Radiation Safety Associates, Inc.

Re: License No. 06-30007-01
Docket No. 030-33025
Control No. 581256
RSA Laboratories 21 Pendleton Drive Decommissioning Report

Listed below are answers to your questions about the above referenced decommissioning report. We have repeated your questions below (in bold) with the responses supplied beneath.

ATTACHMENT A
RSA LABORATORIES FINAL STATUS SURVEY 21 PENDLETON DRIVE

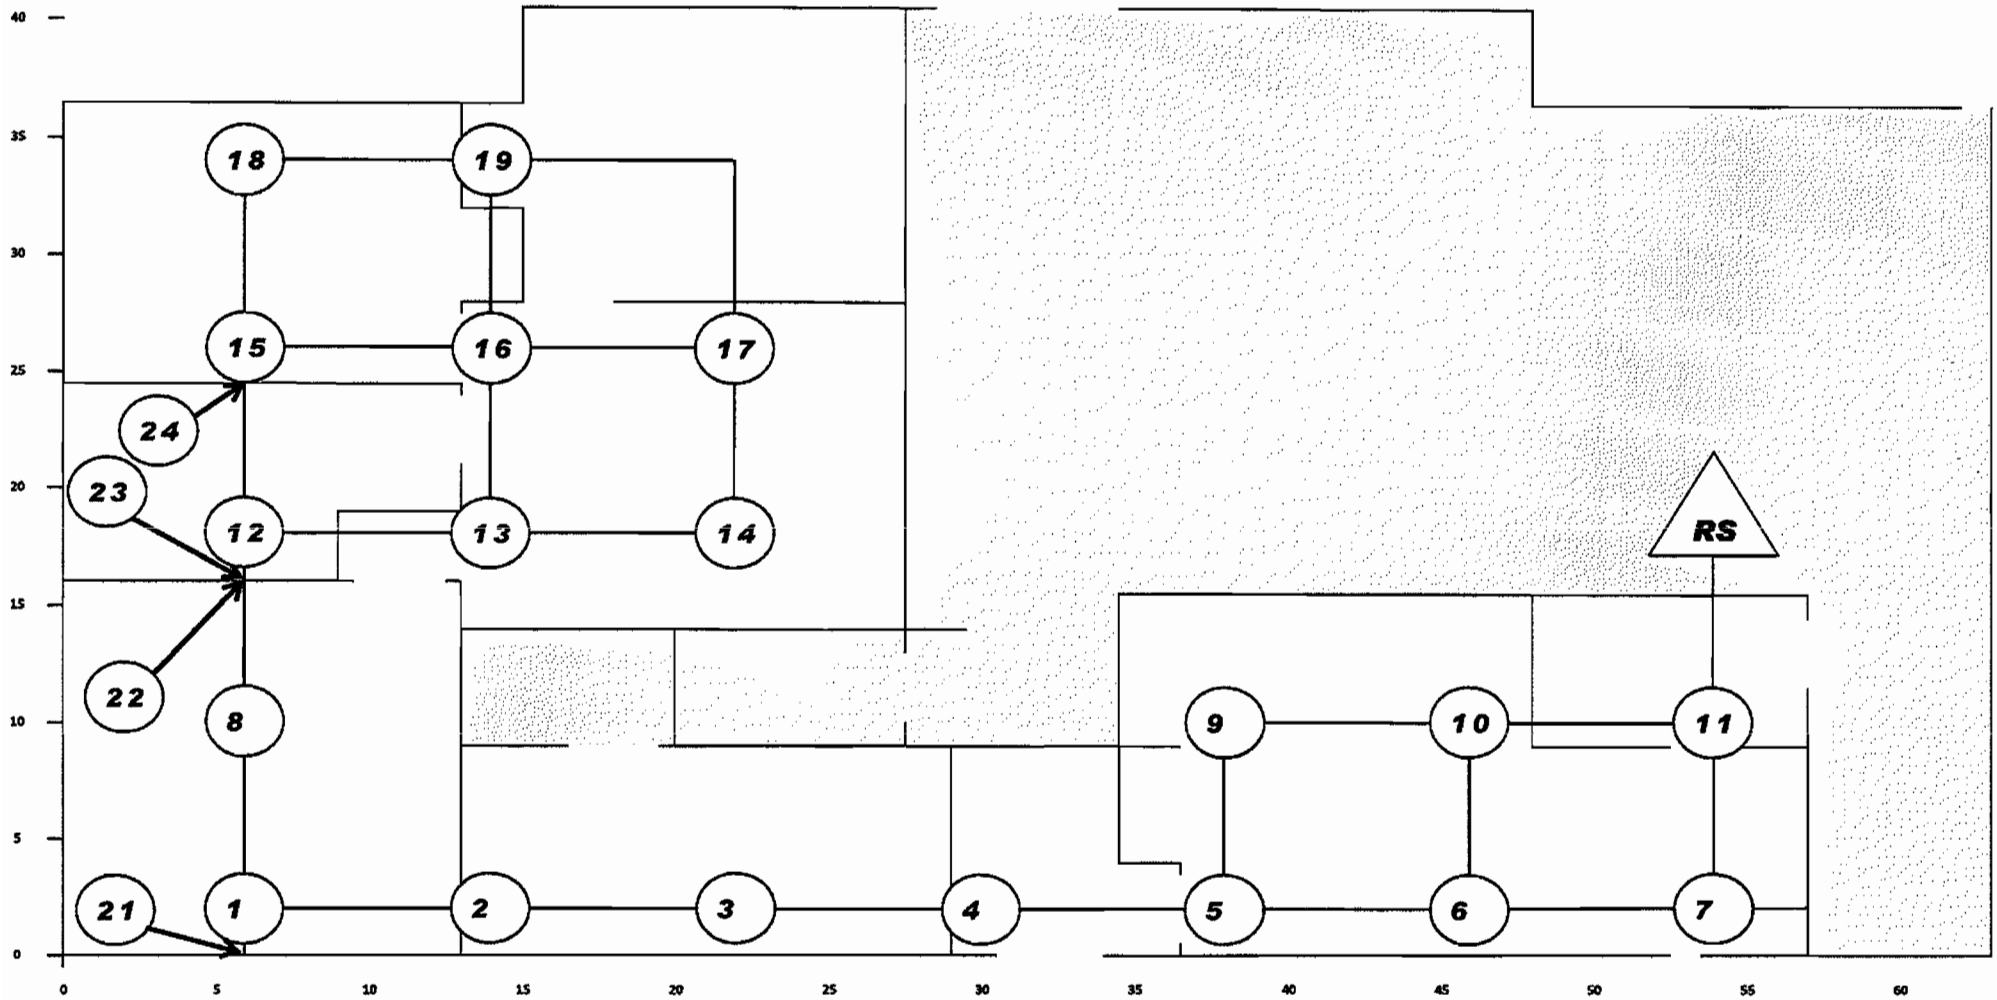
7. Section 9.0 states that the total laboratory area is 118 square meters and is considered a single Class 2 area. However, the direct measurement and scan surveys were performed only of floor areas. Explain if the walls and ceilings were included in the Class 2 area, or should have been included in the Class 2 area. If the walls and ceilings were not part of the Class 2 area, explain their classification and provide any survey information, if applicable.

8. There are 20 samples for alpha/beta direct measurements on pages C-4 and C-5. Confirm if these are the same 1-20 locations as on pages C-2 and C-3. Explain why there are no direct measurements for total residual radioactivity on the walls. Explain which of the 20 floor samples and the 21 wall samples are part of the MARSSIM random start statistical sample points, and which were additional locations you selected to survey. Section 9.3 refers to grid points and random locations, but I cannot tell which are which. What about scan survey results?

3. The walls up to a height of 2 meters above the floor in the Radioactive Materials / Rad Waste Storage Room and the Chemistry Lab/Sample Prep Room have been classified as MARSSIM Class 2. Sampling points on the walls in these two rooms were added to the existing grid by extending the grid to and up the walls.

Response: See the response to question 7. A new map of the MARSSIM sampling points and is attached (Attachment A). The additional wall sampling points are numbers 21 through 24 in the prep room and storage room. Direct measurement results are located on Attachment B (alpha) and C (beta) for all sample points. Wipe results are located on Attachments D (gas proportional analysis for gross alpha/beta) and E (liquid scintillation analysis).
